## OVERALL COMMENTS

## RECOMMENDATIONS

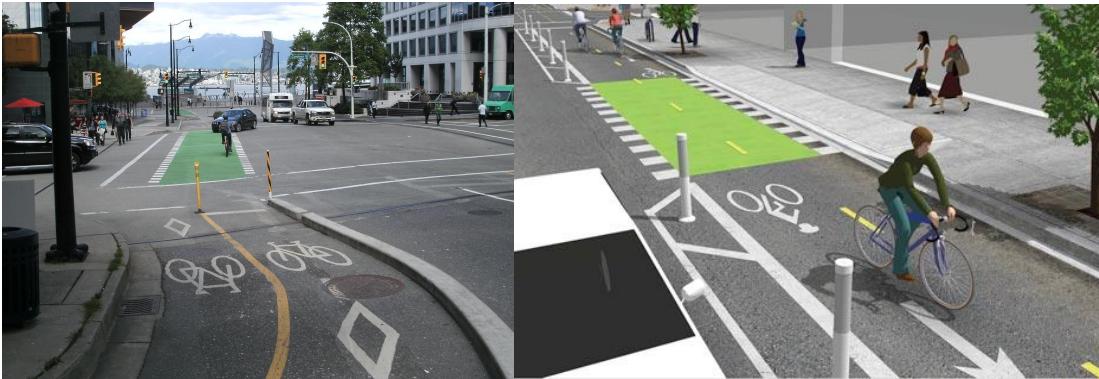
- **Recommendation #6:** Where possible, add two-way bikeways on collector roadways instead of a bike lane or a sharrow going in each direction. (76<sup>th</sup> avenue / Saskatchewan Drive)

- Configuration: two way bike lane, two way vehicle lane, one parking lane
  - By consolidating the two bikes lanes on one side of the road you achieve the following:

- Less conflict between vehicles and bikes
    - Provides a dedicated areas for bikes to reduce the potential for pedestrian / cyclist conflict
    - Provides a safer venue for more bike traffic. Some studies show there are several kinds of cyclists. Daily commuters are generally stronger cyclists and more likely to cycle in and amongst vehicle traffic. However there is a large segment of the population that bikes on sidewalks beside busy roads (more like a pedestrian) due to their perception of safety. They do this even though sidewalks are supposed to be for pedestrians. Providing a safer, dedicated area for cyclists would encourage more of the cycling population to use the bike lanes.

- A dedicated bike lane is more visible if it is wider. Would result in vehicle traffic staying out of it. Recommend painting the asphalt

green to further delineate the difference between bike traffic and car traffic

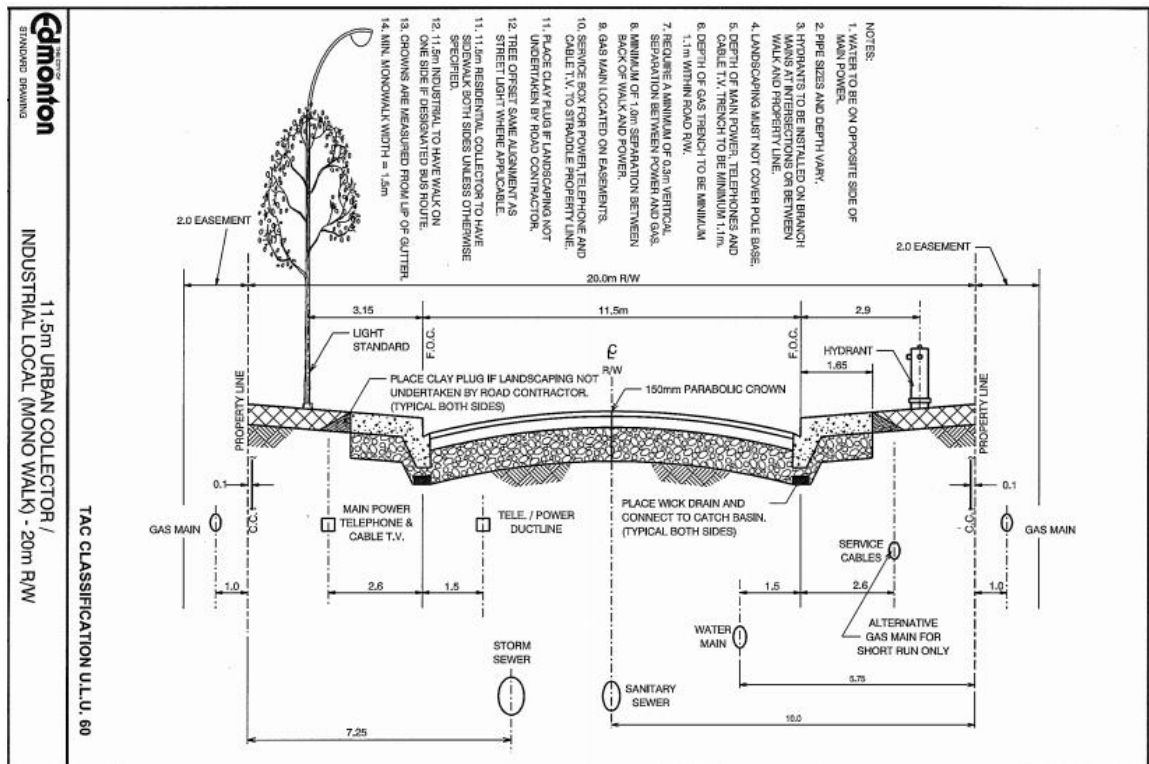
- **Recommendation #6A:** Consideration of winter climate for bikeway delineation.
  - Some bikeways have used physical barriers to further delineate the vehicle lanes from the bikeway.

- Physical barriers on bikeways are ideal because they create a hard delineation between the cyclists' space and the vehicles' space. However, by adding these in a City like Edmonton it makes maintenance more difficult, in particular with respect to snow removal. This should be considered when creating bikeways.

- If the balance of priorities at any costs tips towards safety, the bikeways can be cleaned with smaller equipment (e.g. skid steers or sweepers).
  - If ease of maintenance is paramount, no barriers would be better.

- One compromise may be to have removable barriers. They could be installed in the spring and removed in the winter. This, of course, would add maintenance which may not be desirable from the City's perspective.

- If barriers to the bikeway do exist, this would necessitate special (i.e. smaller) equipment to clear them - there is a chance that the road gets cleared first and the bikeway does not. This would eliminate the benefit of having the bikeway.
